# CITY OF ALBUQUERQUE

**Re: The Peaks 2 by Markana/ 2600 Glendale Ave. NE**  
**Request for Certificate of Occupancy**  
**Transportation Development Final Inspection**  
Architect's Stamp dated 02-11-22 (B18-D029)  
Certification dated 08-16-24

## TRAFFIC CERTIFICATION

A2.01

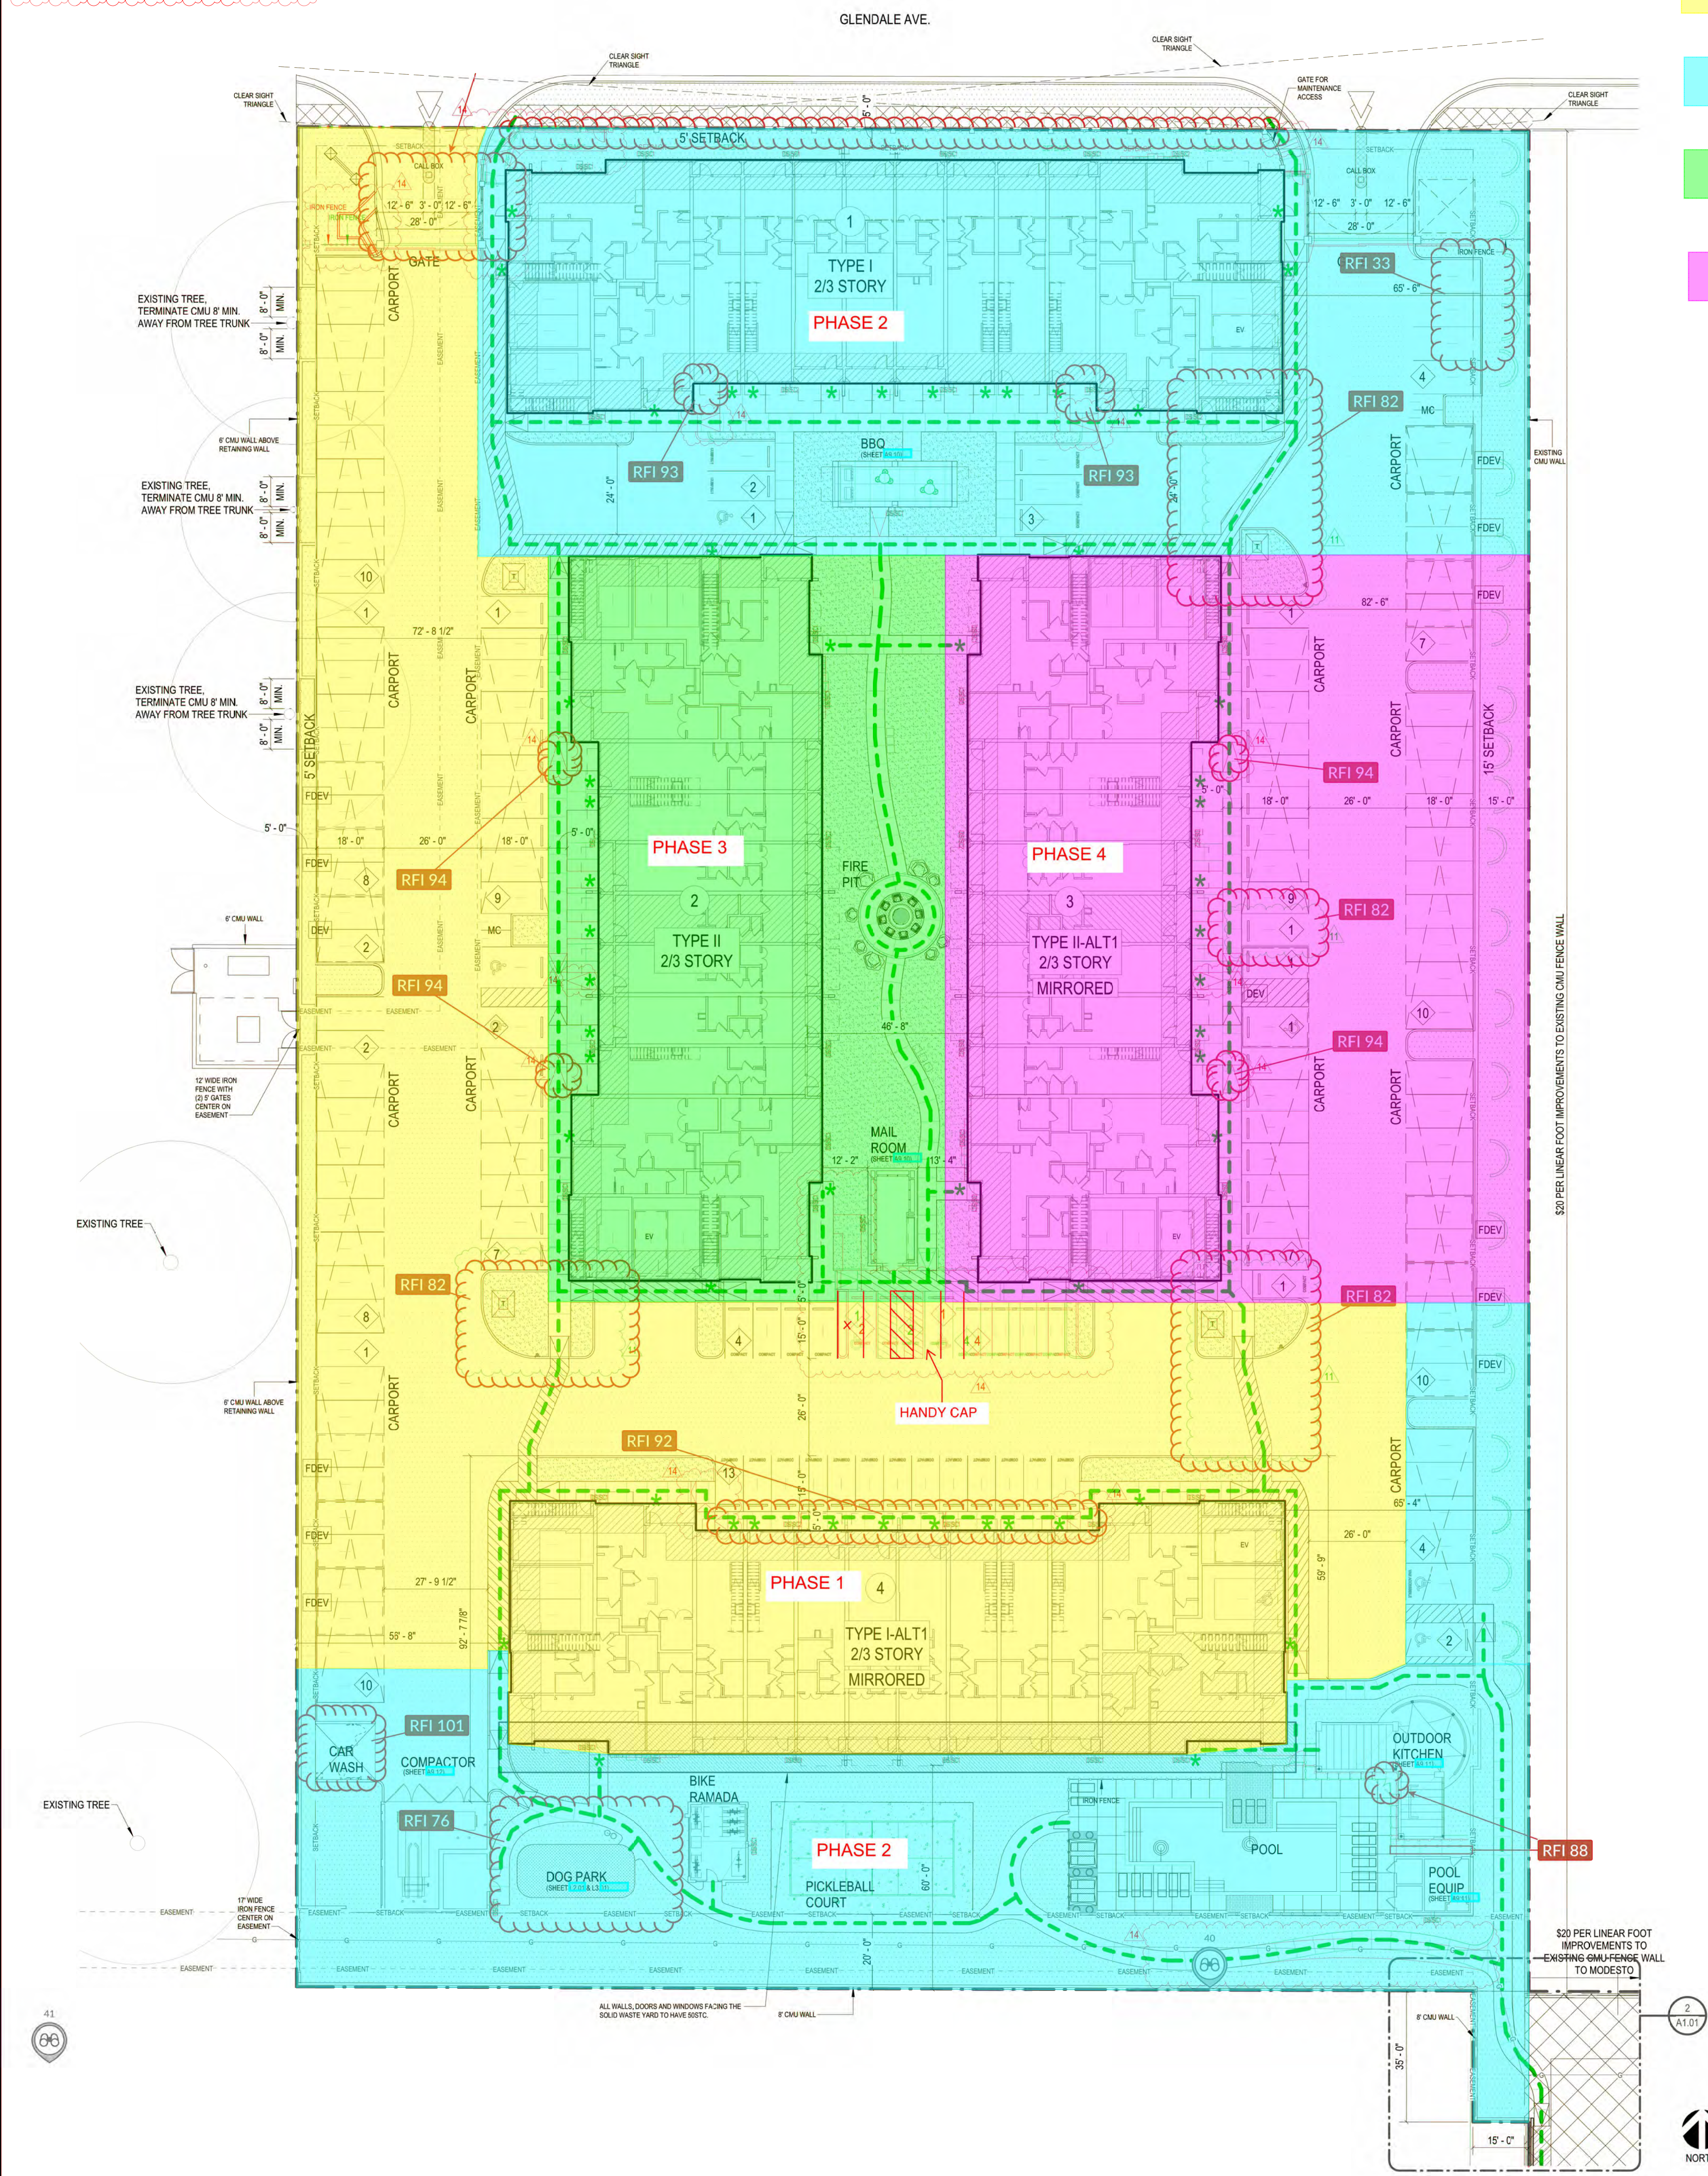
Approved for access by the Solid Waste Department for 1-compactor 1-recycle dumpster. \*\*Solid Waste will not be held liable for any damage to the enclosure to the water heater located in the trash enclosure. \*\* Herman Gallegos 04-06-22

A1.01

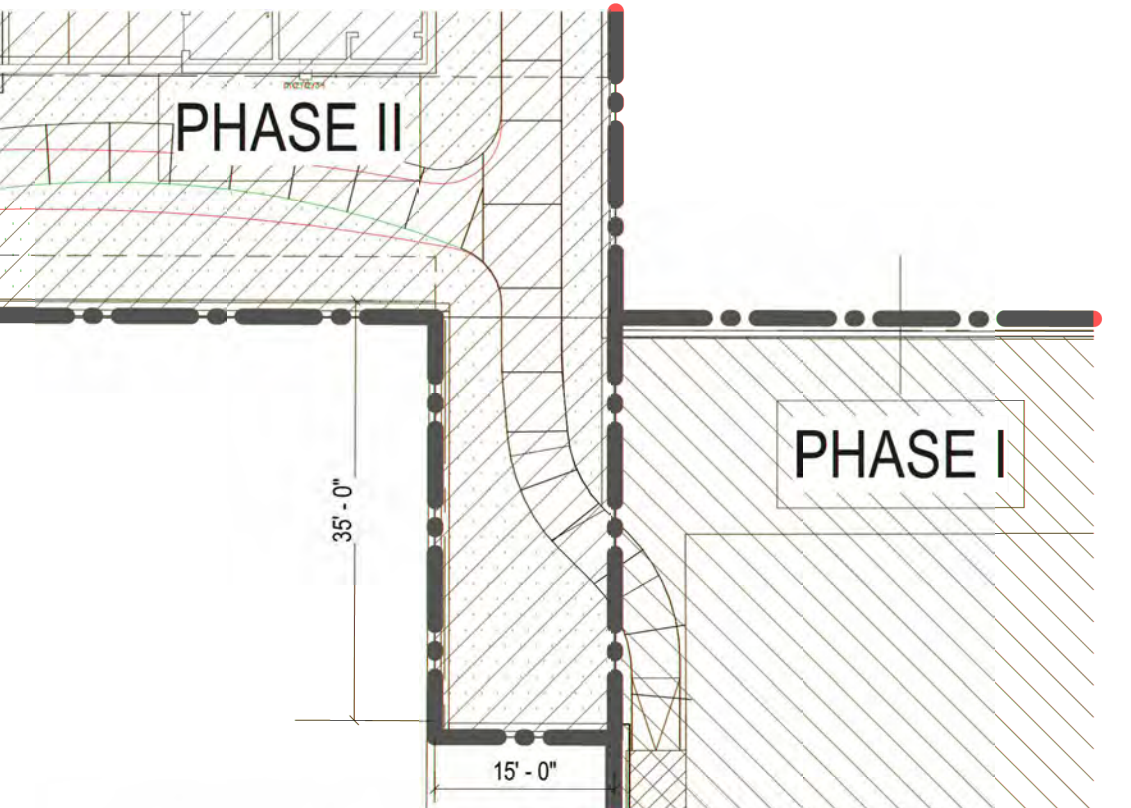
**ASI 14 UPDATE DESCRIPTION:**

- ADDED RAMP(S) TO ACCOMMODATE GRADING UPDATE.
- UPDATED TRANSVERSE FORMER LOCATIONS AND CURBS DUE TO ACCOMMODATE GRADING UPDATE.
- ADDED DRAIN CHANNEL AT NORTHWEST CORNER TO PREVENT ENTRANCE PARKING LOSS FROM CURB REVISIONS.
- UPDATED SIDEWALK AND PARKING AT THE MAIL AMENITY.
